ADDENDUM NO. 1

APRIL 25, 2017

RE: PRIEST RIVER HIGHWAY 2 WATERLINE REPLACEMENT

OWNER: CITY OF PRIEST RIVER

English
COUNTY BONNER
KEY NUMBER 19256
SHEET 7 OF 12

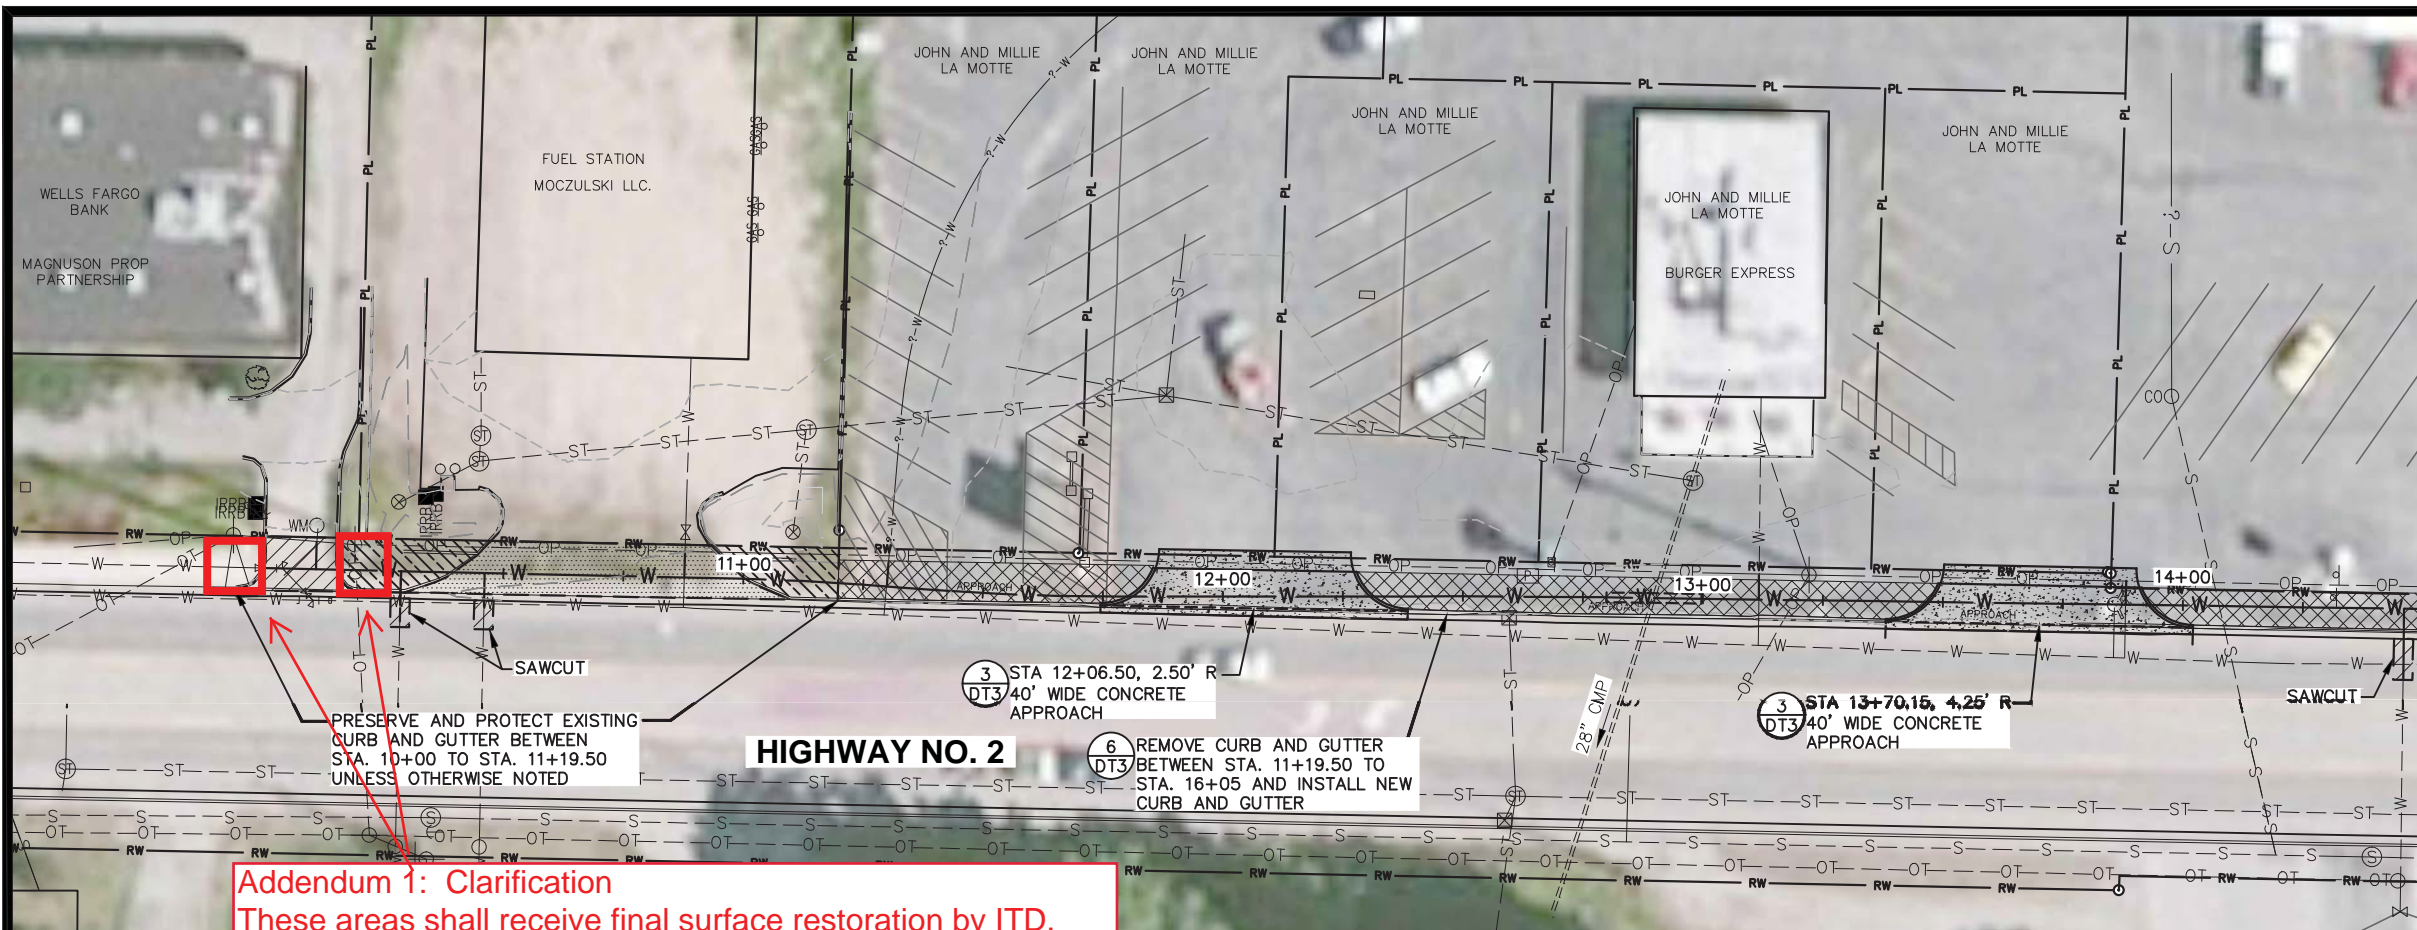
1. ITD will complete ADA ramp improvements at the three locations denoted on the attached Sheet C2. Contractor shall be responsible for placement and compaction of ¾" gravel base rock in these areas only. ITD will complete final concrete ramp as denoted in their attached plan sheet for "ITD FY 19 D1 ADA Improvements."

C2

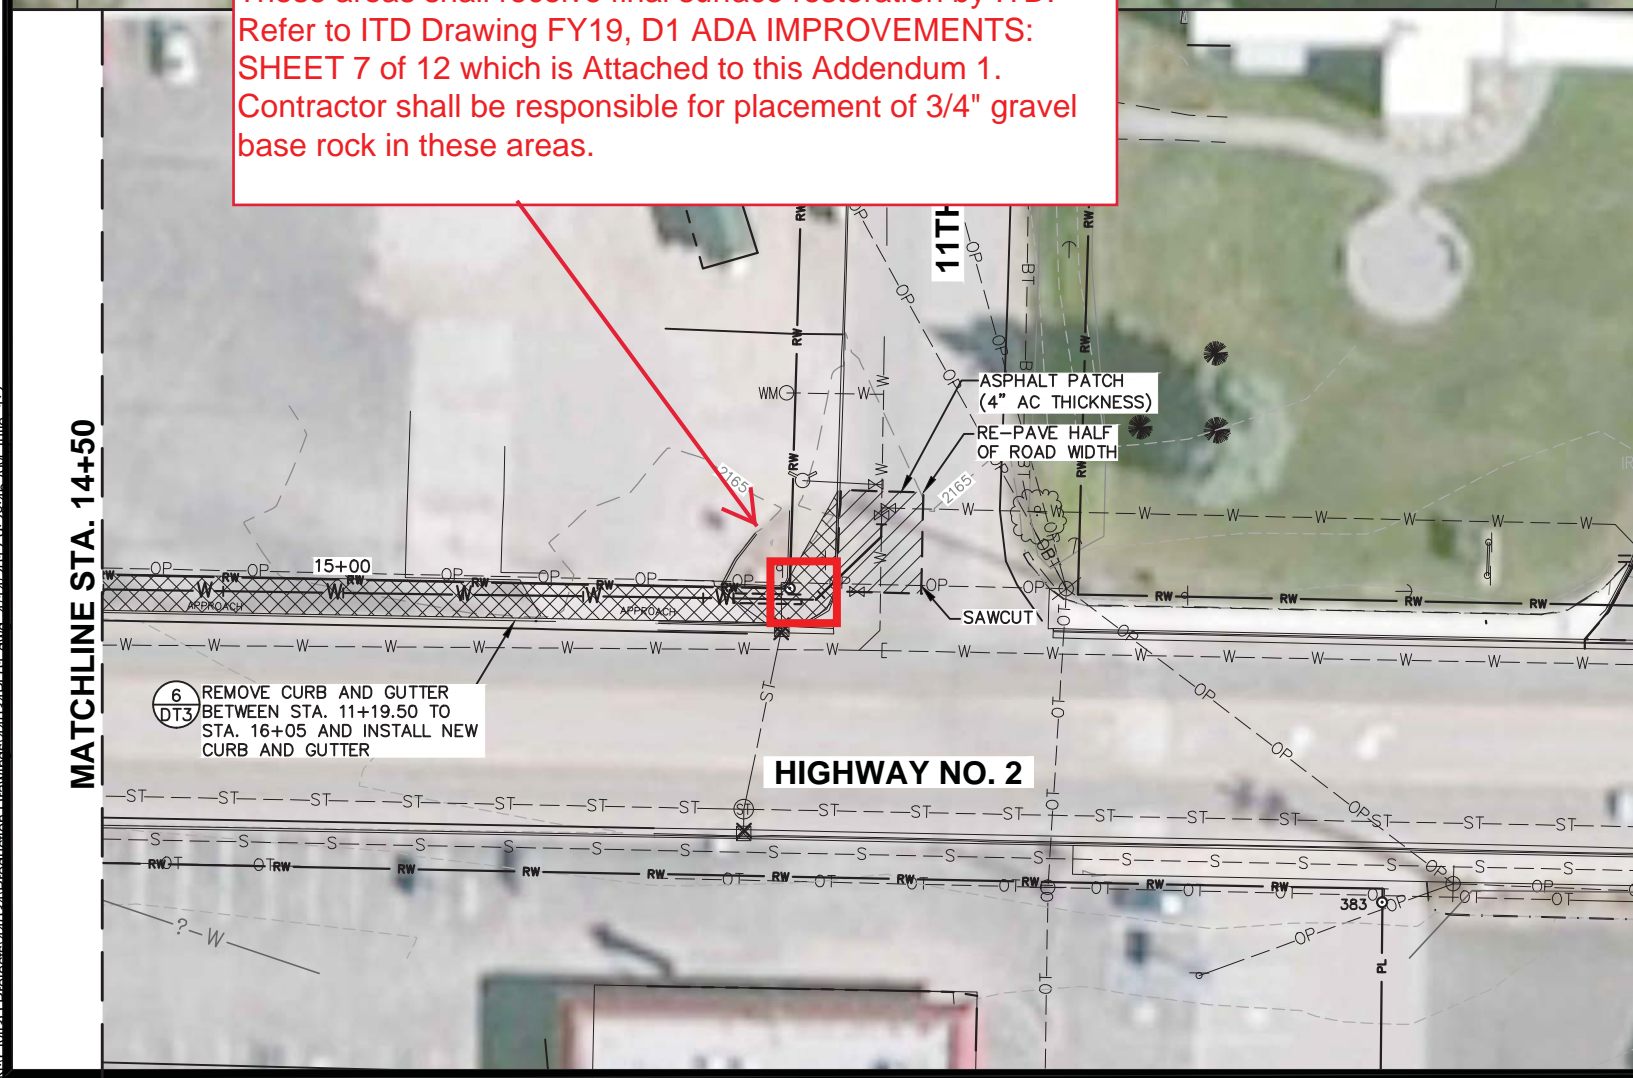
With reference to **Sheet C2, Legend**, revise as follows:

1. The call out for "Concrete Surface Restoration" shall be revised to refer to Detail 3 of Sheet DT3.
2. The call out for "Concrete Sidewalk Surface Restoration" shall be revised to refer to Detail 1 of Sheet DT2.

With reference to **Sheet C2**, refer to **Attachments:**

Addendum 1: Clarification
 These areas shall receive final surface restoration by ITD.
 Refer to ITD Drawing FY19, D1 ADA IMPROVEMENTS:
 SHEET 7 of 12 which is Attached to this Addendum 1.
 Contractor shall be responsible for placement of 3/4" gravel
 base rock in these areas.
